HISTORIC LANDMARK COMMISSION

PERMITS IN NATIONAL REGISTER HISTORIC DISTRICTS JANUARY 23, 2012 NRD-2011-0104 612 E. $6^{\rm th}$ Street

Sixth Street National Register Historic District

Remodel the existing non-historic façade.

EXTERIOR ELEVATIONS

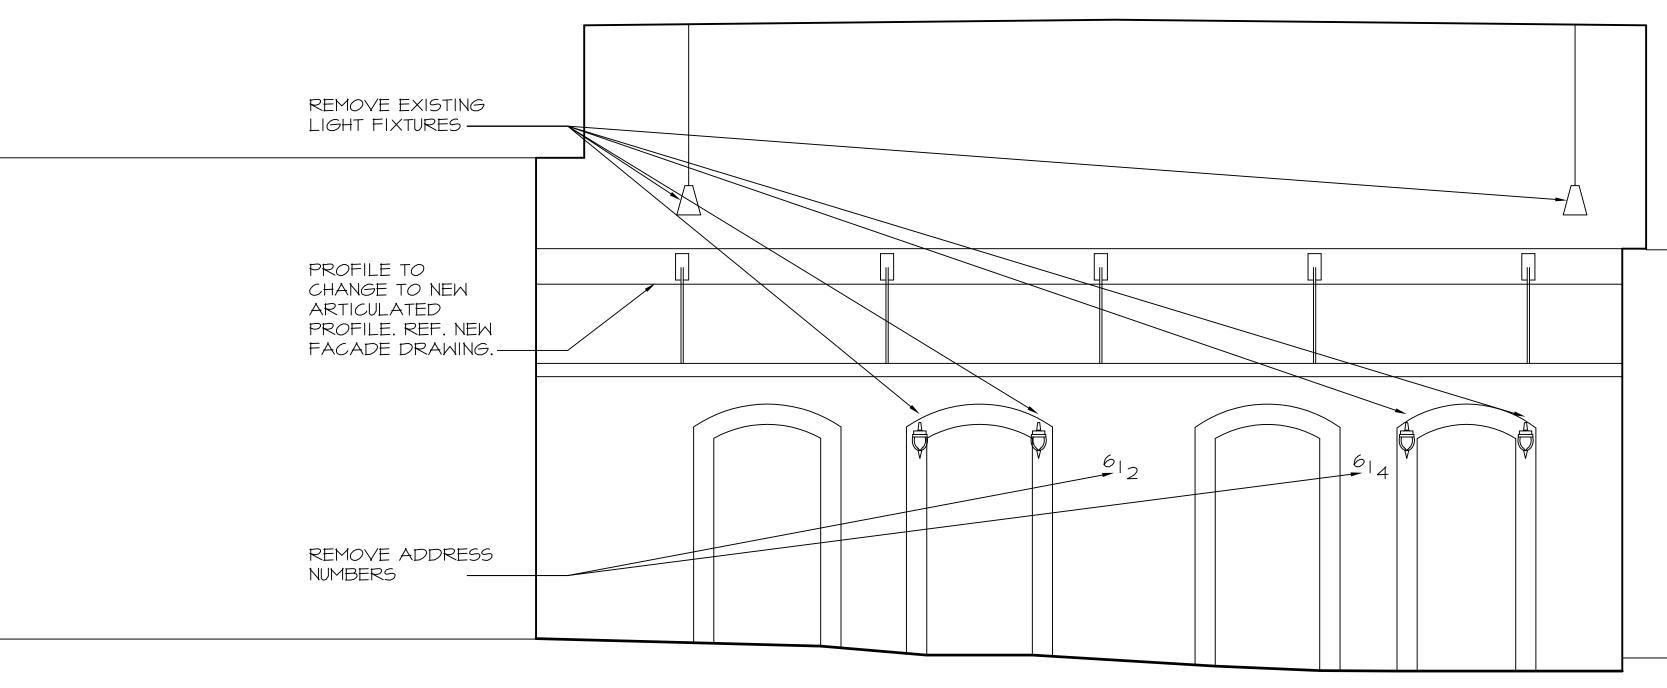
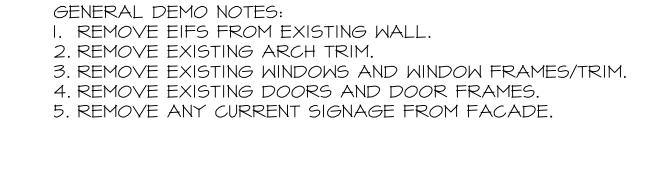
The applicant proposes to remodel the existing non-historic façade by piercing new window openings on the second story, and replacing all doors and windows on the ground floor with aluminum units with transoms within existing openings. The applicant further proposes the construction of a new flat metal awning across the front of the building.

Release the building permit. Unfortunately, this building has been changed to such an extent that restoration of the original one-story building is no longer feasible. The applicant has been very sensitive in maintaining the shape and rhythm of the segmentally-arched bays on the ground floor and mitigating some of the most unsympathetic modifications to this building with a design appropriate for the historic character of the district.
